CITY OF APPLETON

MEMORANDUM

Date: October 29, 2025
To: Board of Zoning Appeals
From: Kurt W. Craanen, Inspections Supervisor
Subject: Variance Request- 1740 N. Clark St. (31-6-1447-00)

Deitte Site Plan (1740 N Clark St)

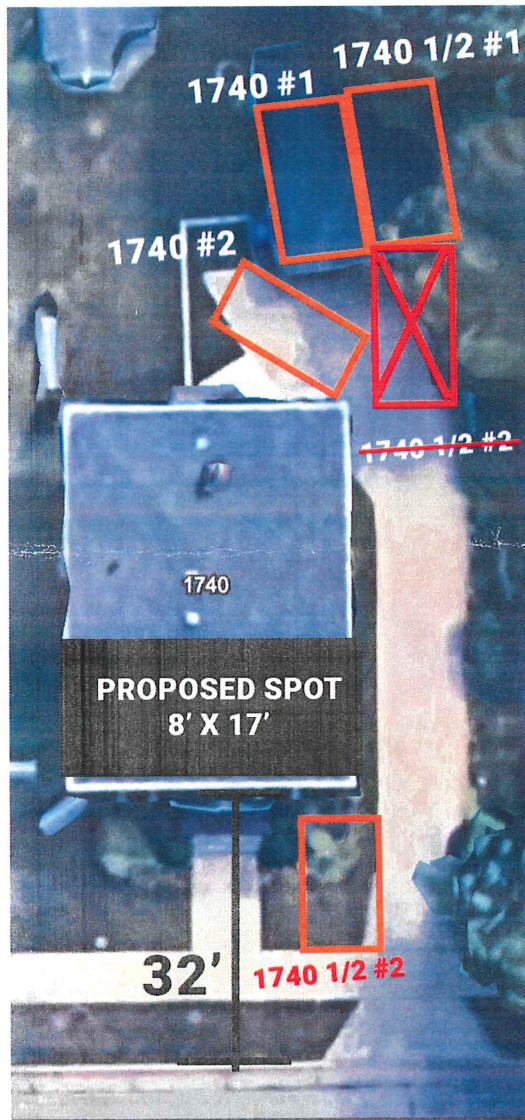
The applicant proposes to install a driveway extension eight (8) feet into the front yard. Section 23-43(f)(3)(g) of the Zoning Ordinance limits driveway extensions to four (4) feet into the front yard.

This parcel is 4,500 sq. ft. The minimum size lot allowed in the R2 zoning district is 7,000 sq. ft. This parcel's width is 45 feet. The minimum lot width in the R2 zoning district is 70 feet. This property is a nonconforming lot of record.

The property does have parking spaces for four (4) vehicles and room to expand in the rear yard. The driveway is long and there are parking spaces near the garage.

The property is code compliant in it's current condition. The applicant's hardship is based on the inconvenience of moving cars around. This is common with many households and is not a legitimate hardship.

Staff recommends denial of the variance request to allow a parking extension eight (8) feet into the front yard because the hardship criteria has not been met.
